Council Records

Your application dated 28 January 1983, for permission to erect a wooden retaining wall at No. 5 Ambury Place, Lot 1, DP 11855, has been examined and in accordance with the provisions of Clause 2.9.1 of Chapter 2, NZSS 1900, I have to advise that because insufficient information has been supplied relative to Acts, Regulations and By-laws administered by Council, the issue of the required permit is withheld until the following information has been supplied by way of amendment or addition to the plans and specifications deposited.

Proposed retaining wall between 3 & 5 Ambury Place N.P.
3 & 5 Ambury Place Mr. P. Whalen.
Drawn by John Turner
Builder: J. Turner Ph. 86481

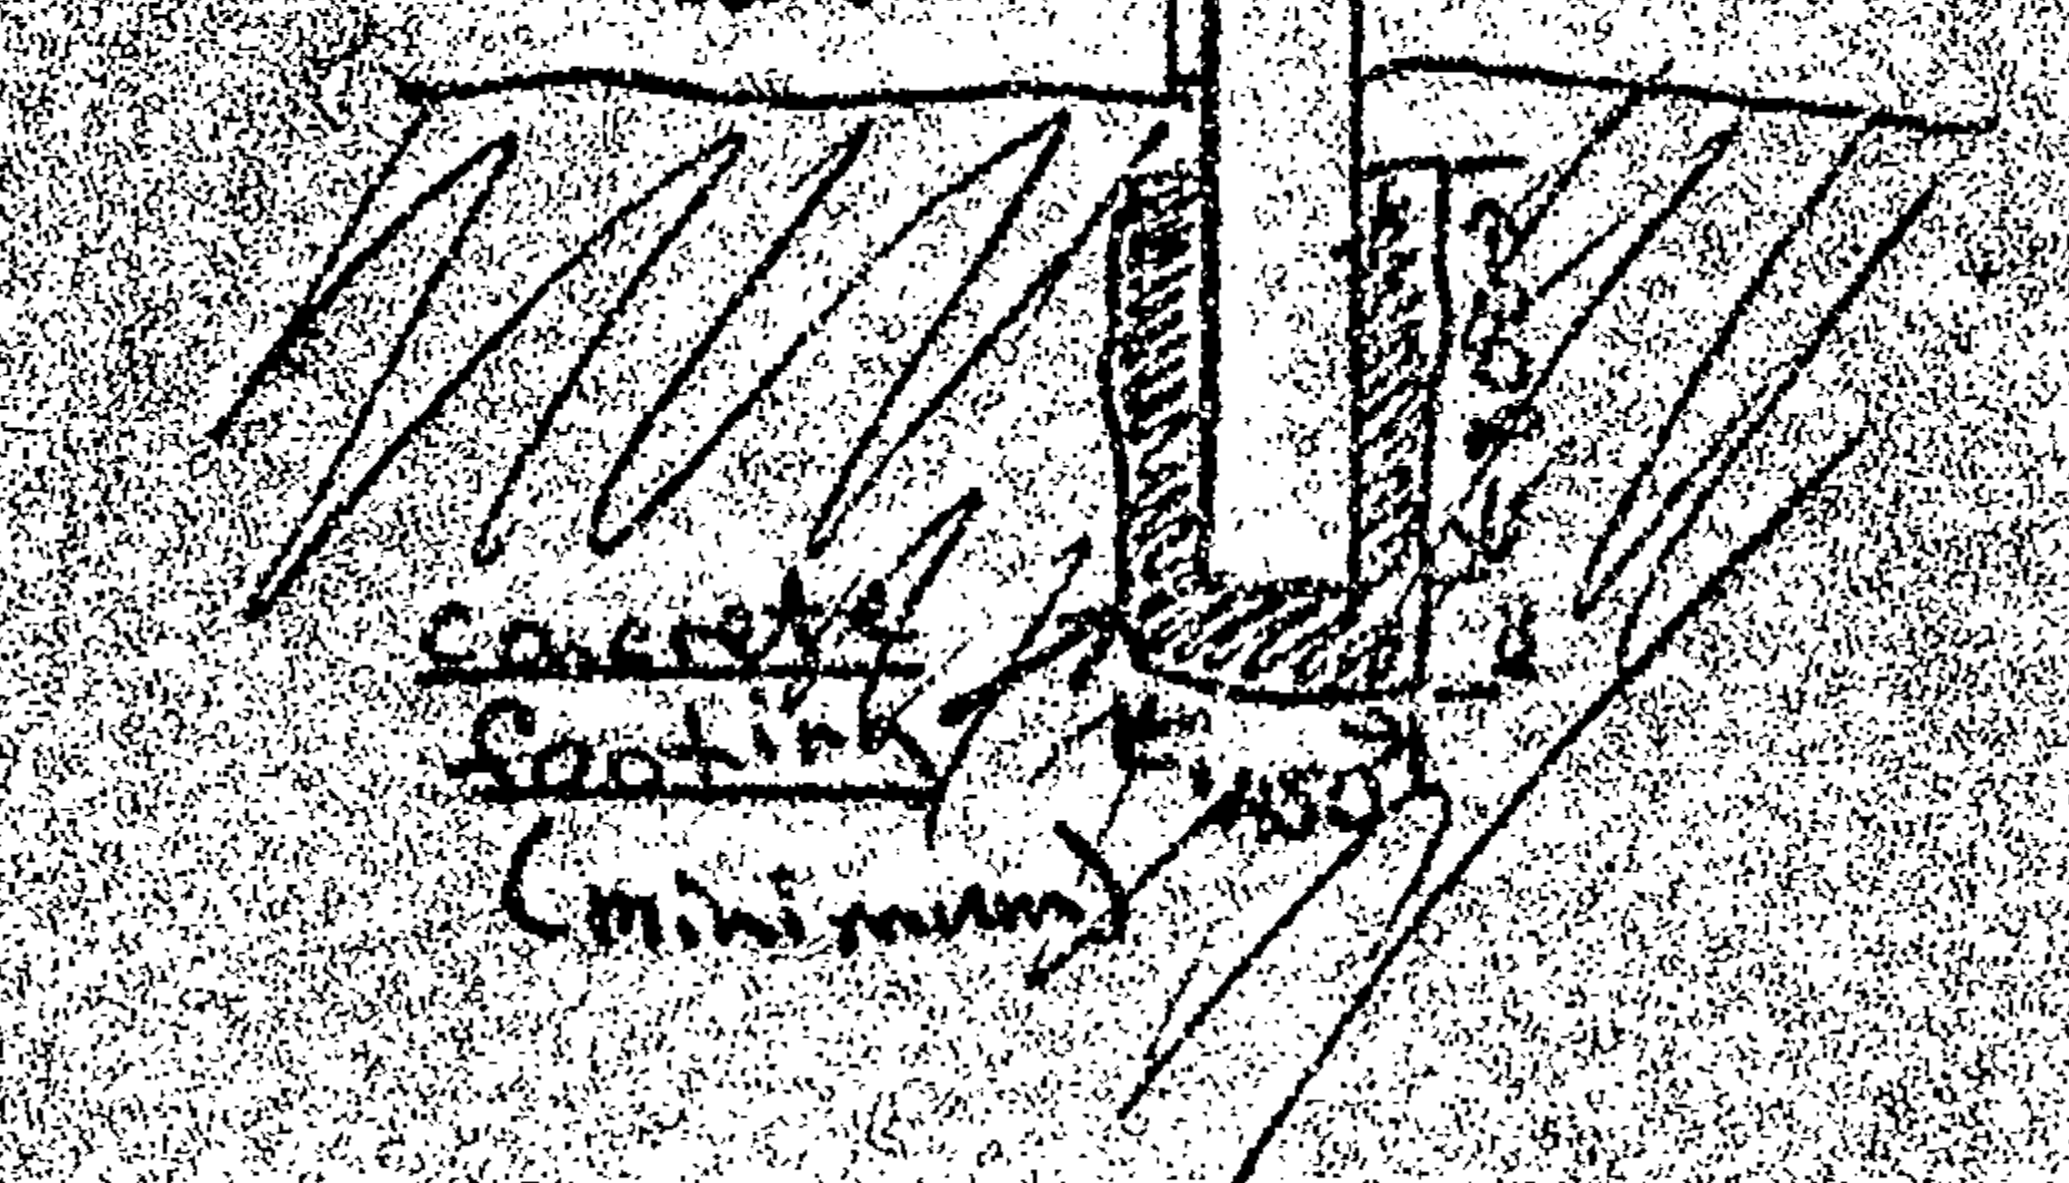
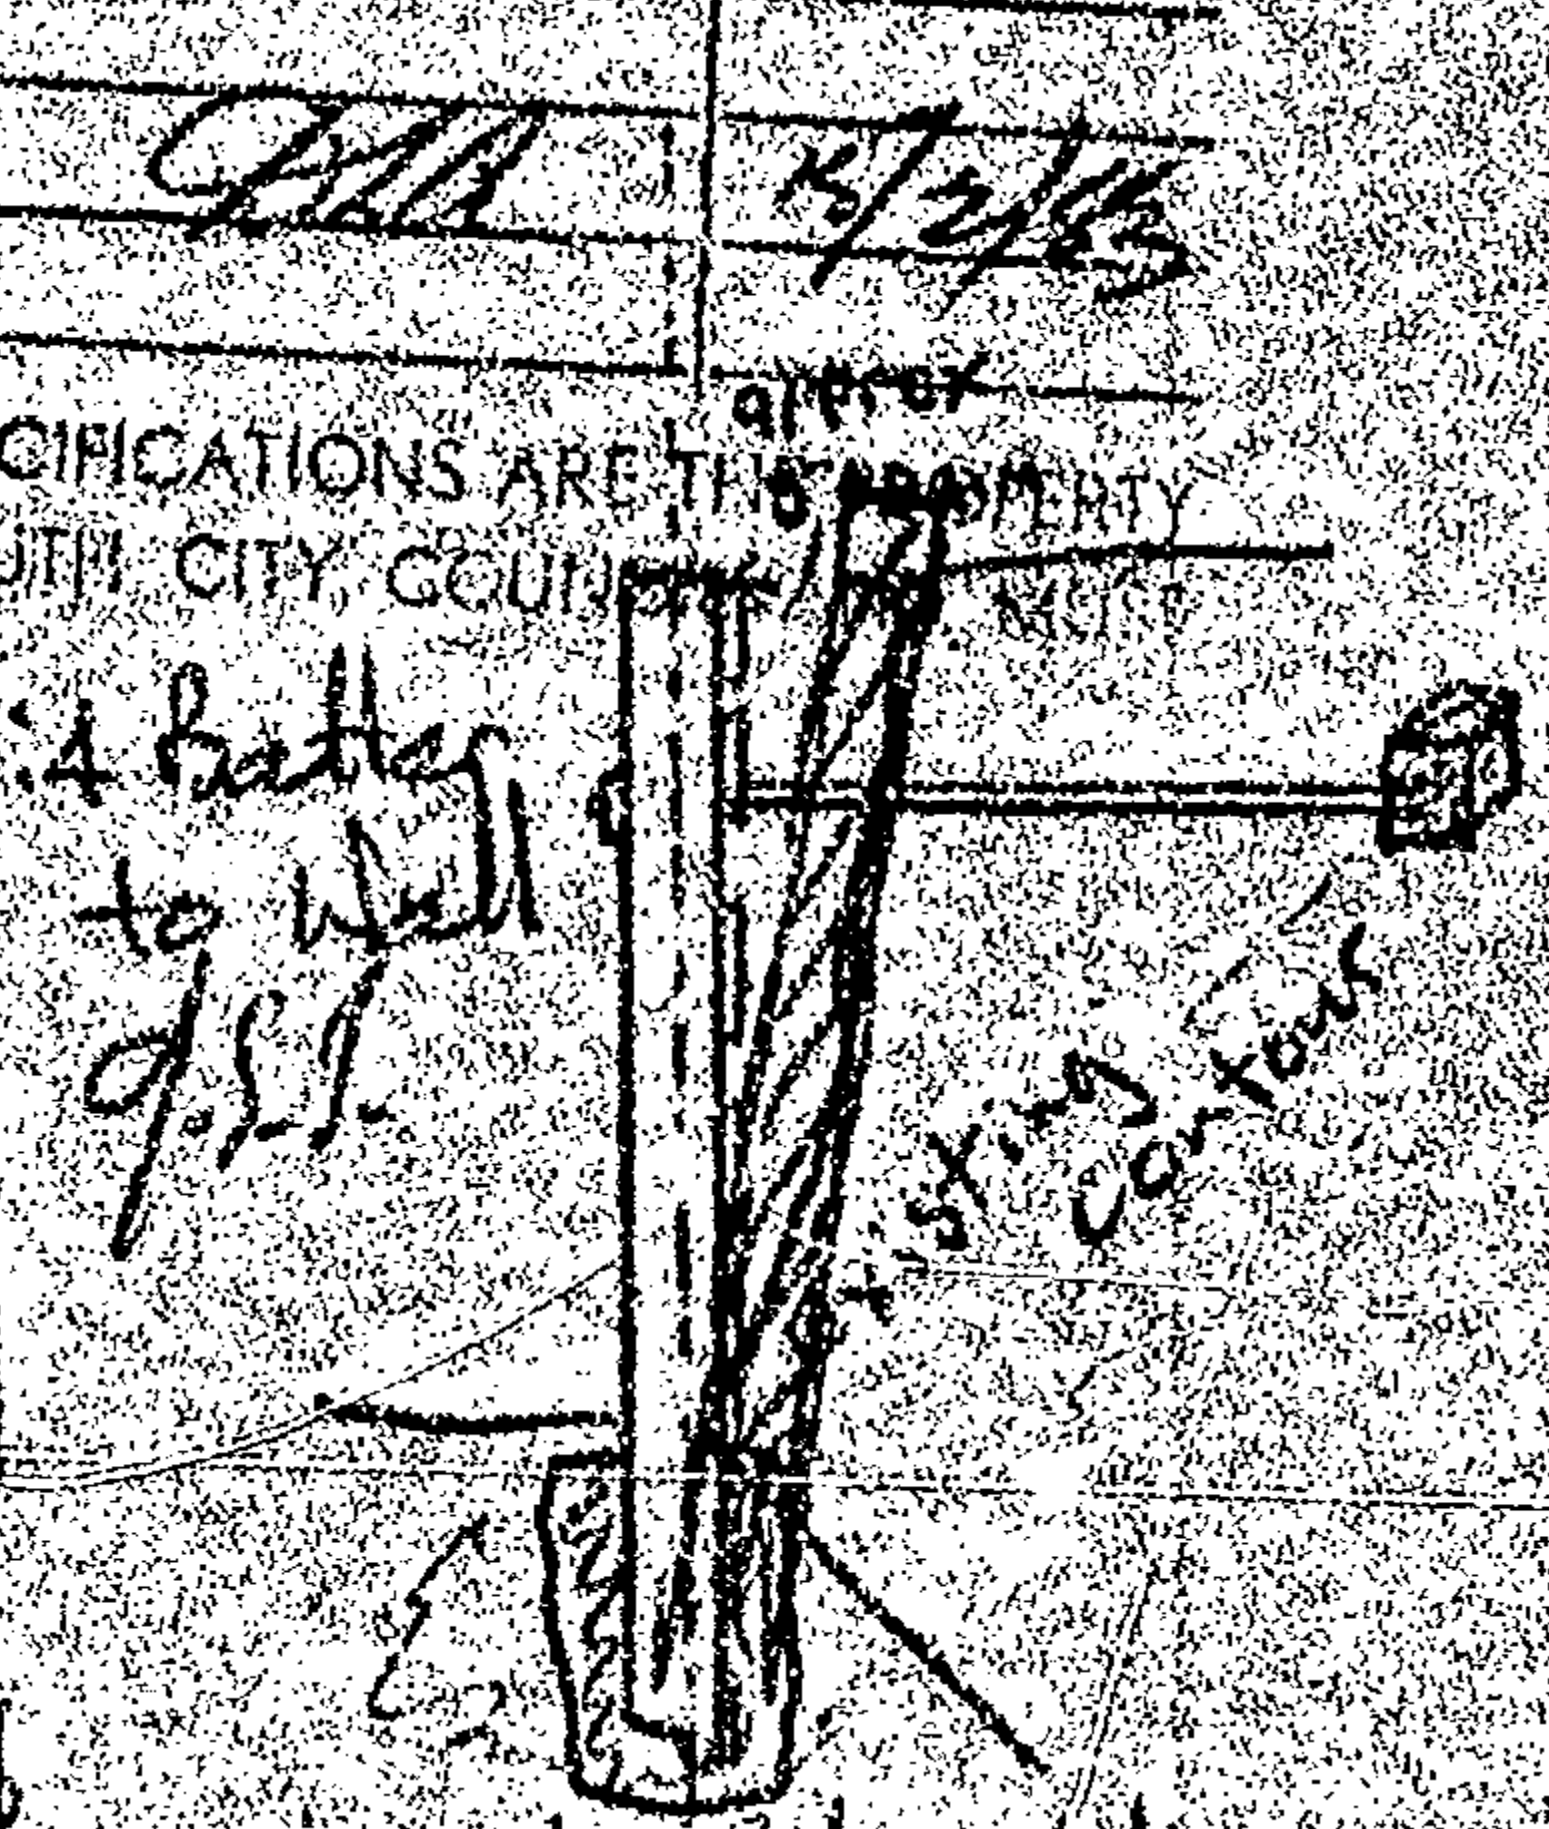
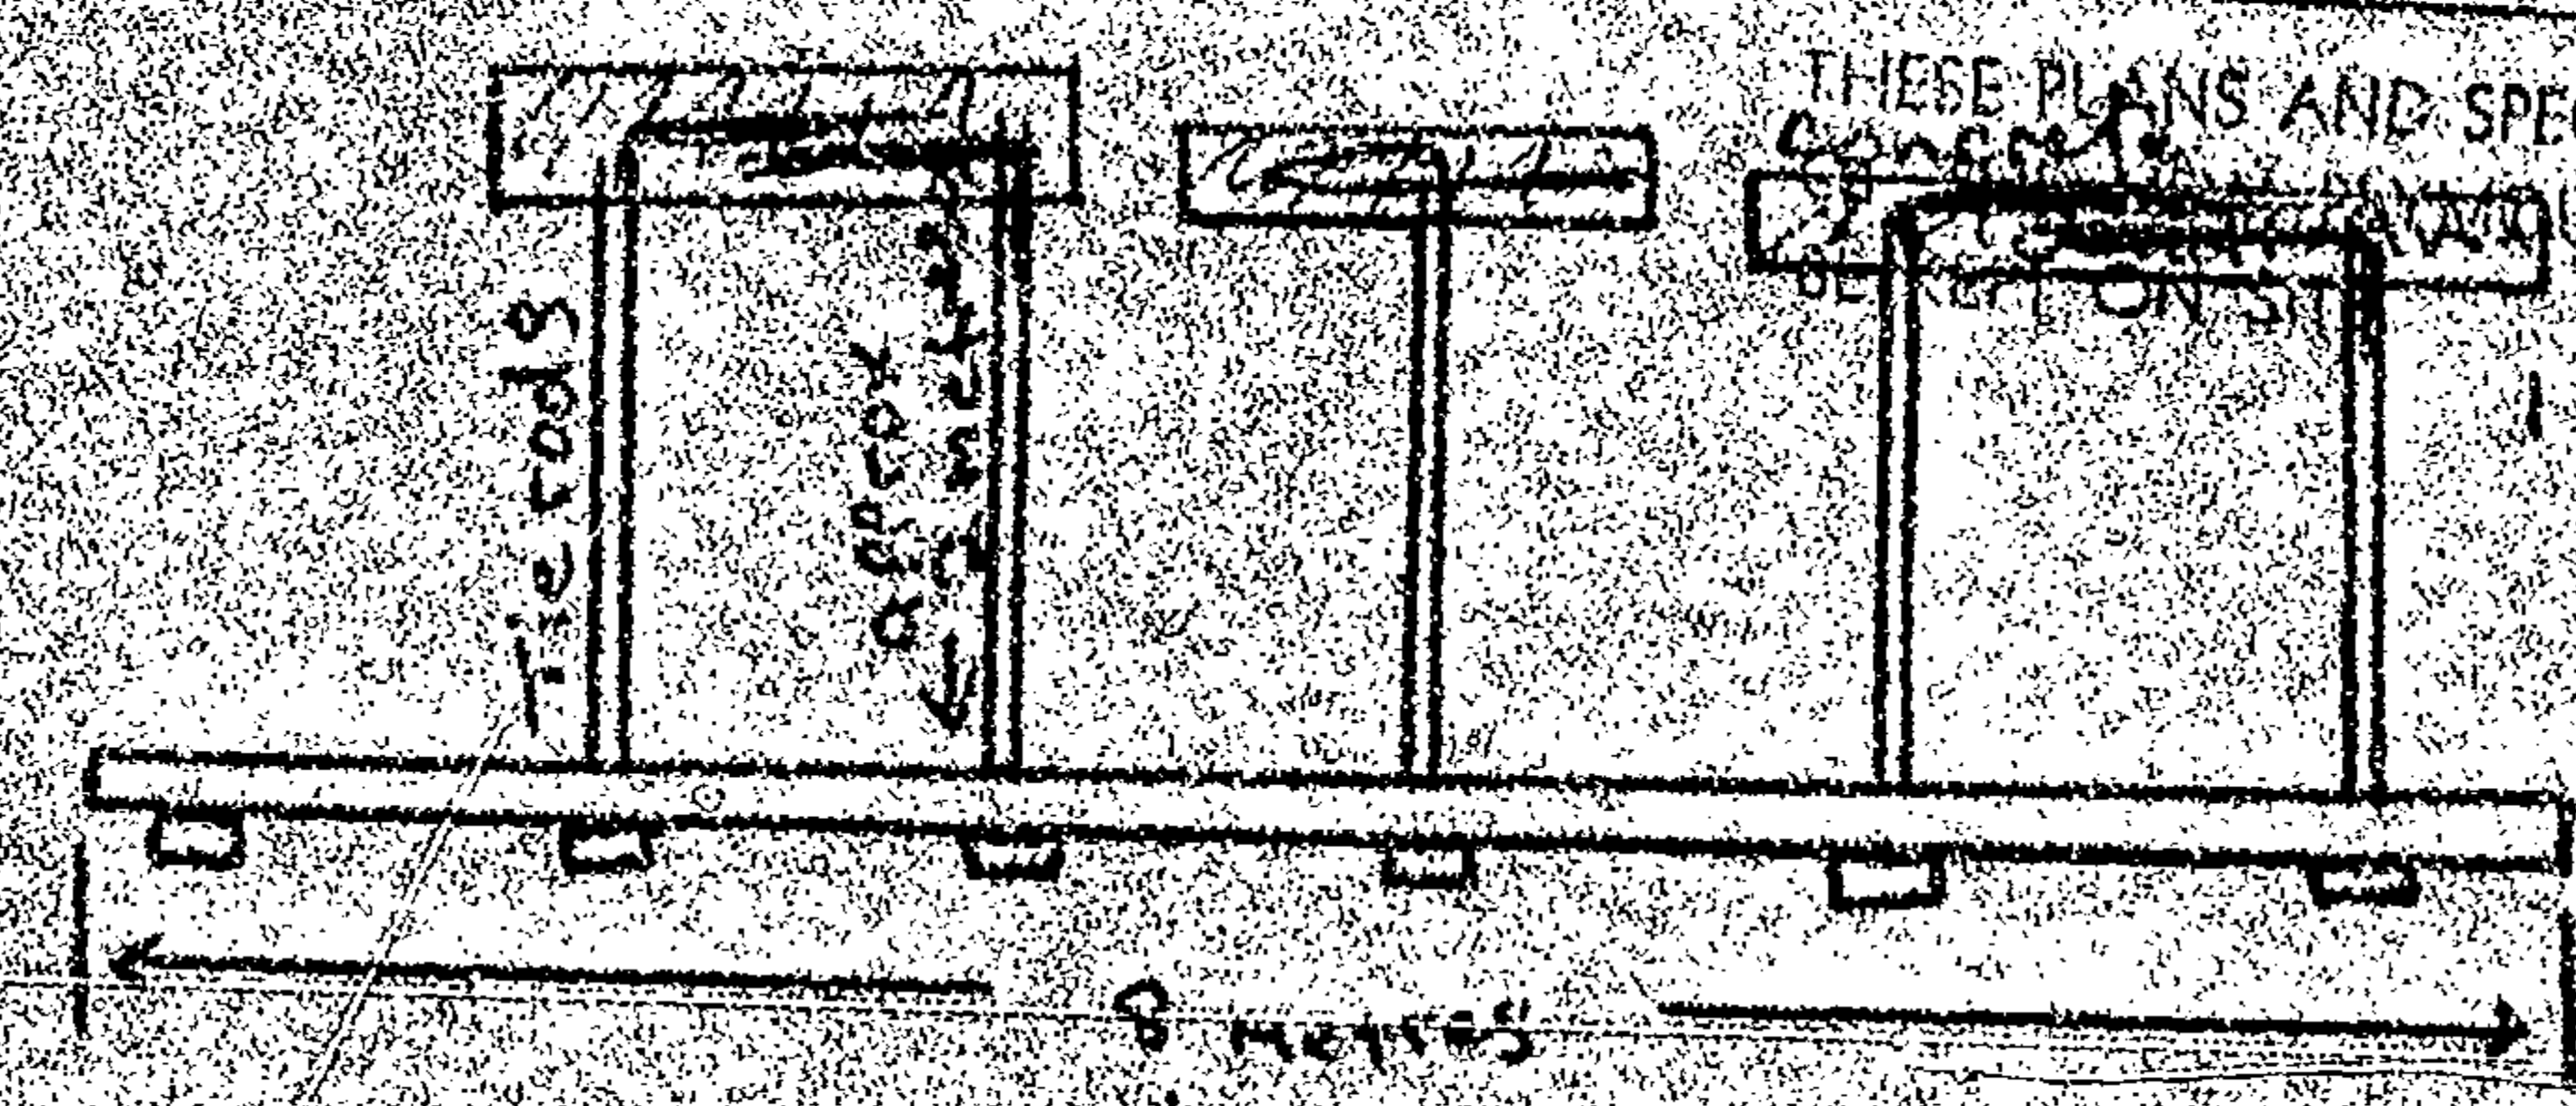
The retaining wall is to be built clear of the actual boundary within the property of the applicant.

Plans are to be amended.

Calculations relating to the wall are to be provided. *Not Req*

Approved painting footings of wall are not placed
over existing series of stormwater pipes.

Remarks: *The retaining wall is to be built clear of the actual boundary within the property of the applicant. Plans are to be amended. Calculations relating to the wall are to be provided.*
